# SAN FRANCISCO PLANNING DEPARTMENT

**MEMO**

**RE:** **Review and Comment - 433 Mason Street**  
**Case No. 2016-2016-014360PTA/CUA/DNX**

The Department would like the ARC to consider the following information in its review of the Project Sponsor's design submittal (dated as received on February 12, 2018), which includes a **Visual Compatibility Analysis on Sheets A.012 – A.019**:

② DERBY ST ELEVATION (SOUTH)  
1" = 50'-0"

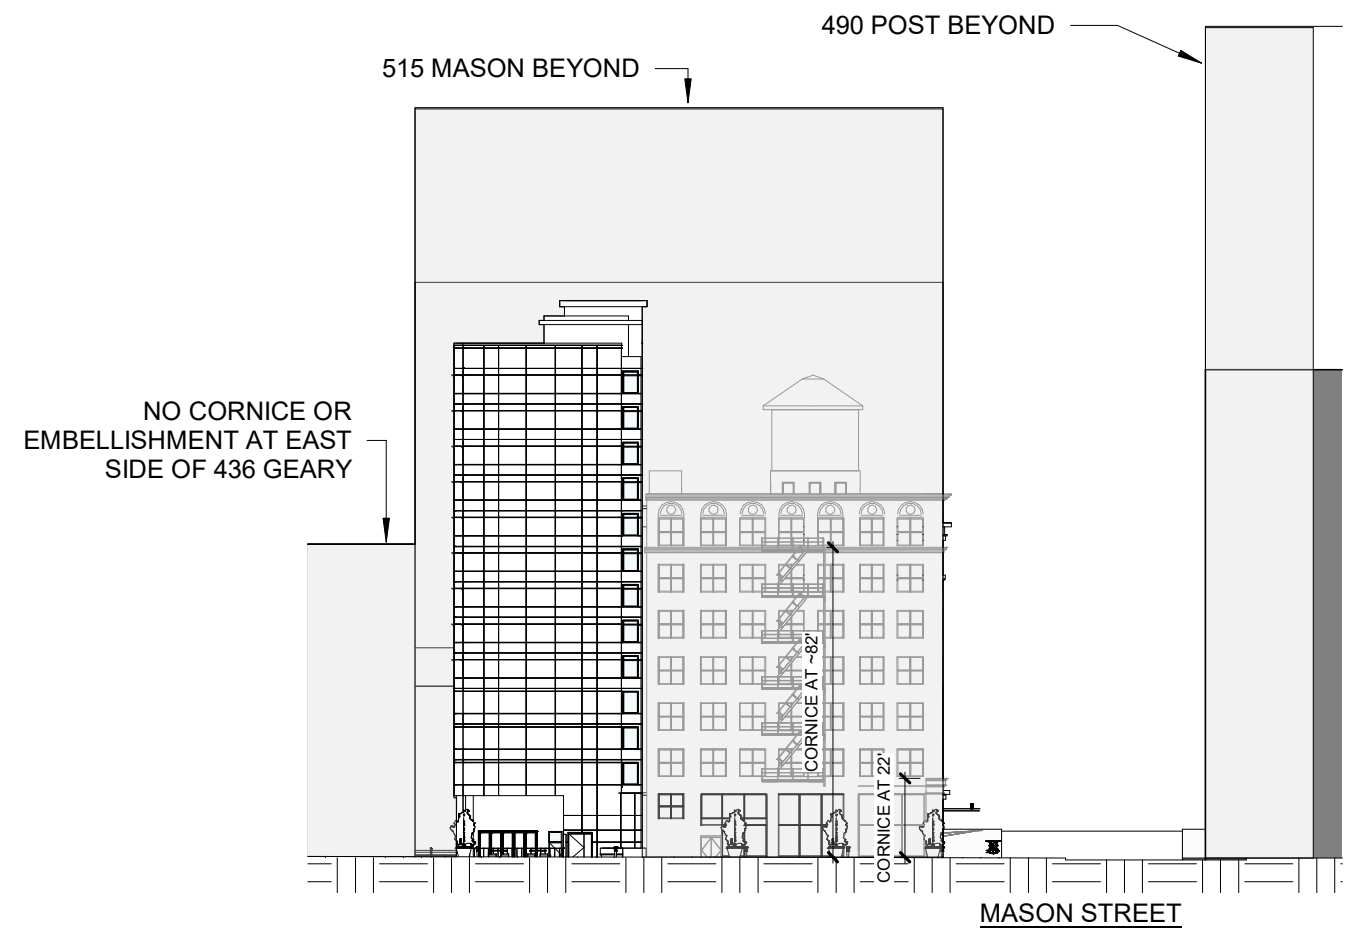
The west wing of the hotel rises straight up from base to roof in a relatively uninterrupted manner. The double-height recessed treatment of the Derby Street building base could be interpreted as a modern, inverse approach to creating a distinctive building base. At the elevator cores, the rooftop enclosures create a taller, symmetrical massing on the east-facing façade, which are capped by cornice-like metal roof canopies.

- At the base of the Derby Street – West Wing, department staff recommends continuing the horizontal line created by the upper edge of the 2-story recessed base across the

remainder of the façade in some fashion – perhaps with a slight change in material below that line -- to visually anchor the base of the Derby Street elevation.

**EXT. DETAILS - ENTRANCE  
RENDERING**

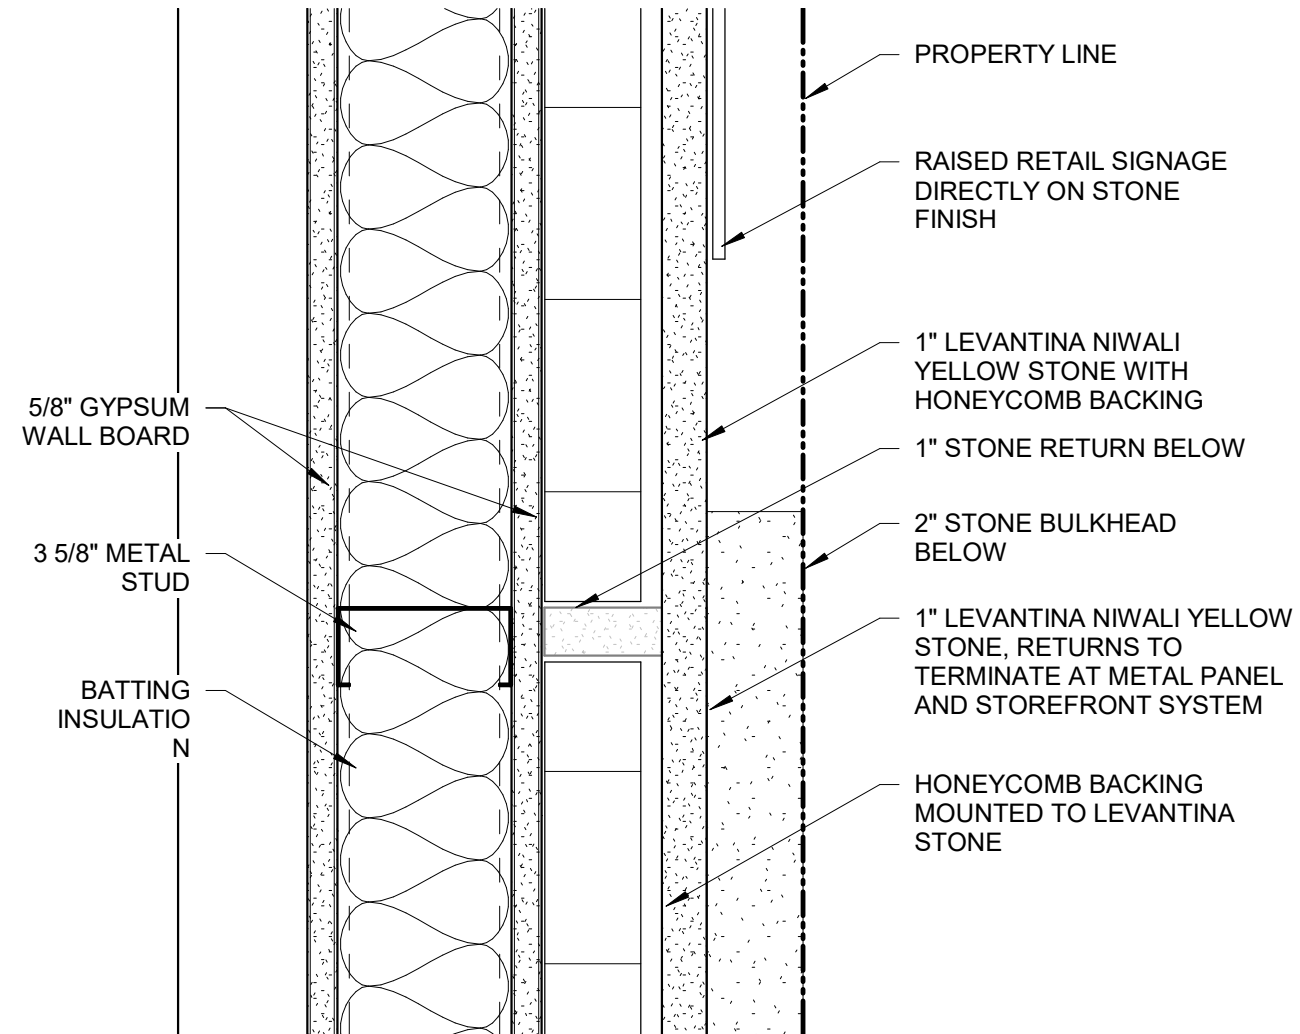
- Department staff finds the Mason Street hotel entrance awning to have a more industrial aesthetic than is characteristic of the district's period of significance, and would recommend further study of this detail prior to review by the Historic Preservation Commission.
